RE: Comments on 'Response to Kondolf (2017) "Review of the Sonoita Creek Mitigation Project Proposal for the Proposed Rosemont Copper Mine"' by Water & Earth Technologies, January 2018

**Comments on 'Response to Kondolf (2017) "Review of the Sonoita Creek Mitigation
Project Proposal for the Proposed Rosemont Copper Mine"' by Water & Earth
Technologies, January 2018**

G Mathias Kondolf, PhD

25 September 2018

Figure 1. Design for artificial channel proposed to replace Sonoita Creek, showing sinuosity of over 1.36 from confluence of Tributary E1 to Tributary E3 (detail from WET Drawing 11, excerpted from my 2017 report).

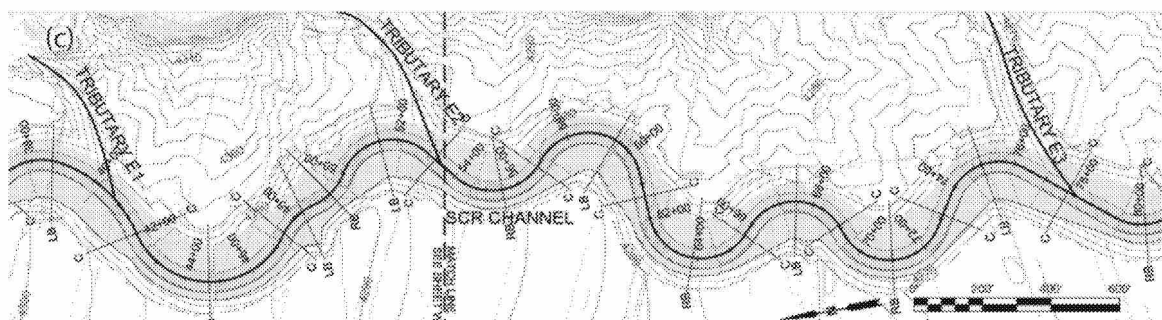
In my 2017 comments, I noted the high sinuosity of the proposed artificial channel (Figure 1), and I pointed out that many stream reconstruction projects elsewhere had failed by the channel cutting across meander bends and creating a straighter channel than what had been constructed. This is a serious concern, especially because the generous credits the proponents claim for the artificial channel are based on the unnaturally large meander bends proposed and the consequently increased length of the channel. I noted that the sinuosity of the Sonoita Creek channel in Rail X Ranch and from the ‘reference reach’ downstream to the point where Sonoita Creek begins to follow Hwy 82, and the sinuosity of Walnut Gulch on the ‘reference reach’ identified by WET, were all approximately 1.07, much lower than the sinuosity of the ideally meandering, artificial channel proposed by WET.

In attempting to argue against my critique of the highly sinuous artificial channel proposed, WET (p.11) states that the proposed artificial channel is designed to be flanked by low, easily inundated benches, so that "significant storm events with a flow depth great than 2-feet deep will have a straighter flow path..." Thus, the flow path at higher flows will be straighter, cutting across meander bends. WET introduces a new variable, "dominant sinuosity" of the channel, which WET (p.11) defines as the "sinuosity of flood inundation during the 5-year event," and which will be much lower than the sinuosity of the active channel visible on the plans presented by WET (2017). Introducing this new variable serves to confuse the discussion of sinuosities. It is important to recognize that "dominant sinuosity" is not an accepted term in fluvial geomorphology. Rather, it is a new creation, part of the onslaught of words presented by WET (2018) in its response to my 2017 report. While these words (and their accompanying tables and figures) can initially give an impression of substance, in the end they are mostly irrelevant and fail to support the WET arguments.

More importantly, however, the acknowledgement by WET that high flows will cut across the meander bends supports my point that flood flows are likely to cut across the exaggerated meanders and create a straighter path, eroding the unprotected sediments in the channel banks. The result is likely to be that meander bends will be abandoned and a straighter channel will result, offering far less mitigation acreage than promised for the highly meandering artificial channel proposed for construction.

The proposed design of the artificial channel encourages flood flows to cut across the meander bends, which will almost certainly result in meander cutoffs, which will not be repaired. The straighter channel that results will not have the large mitigation acreage that the proponents seek in the highly sinuous artificial channel they propose.
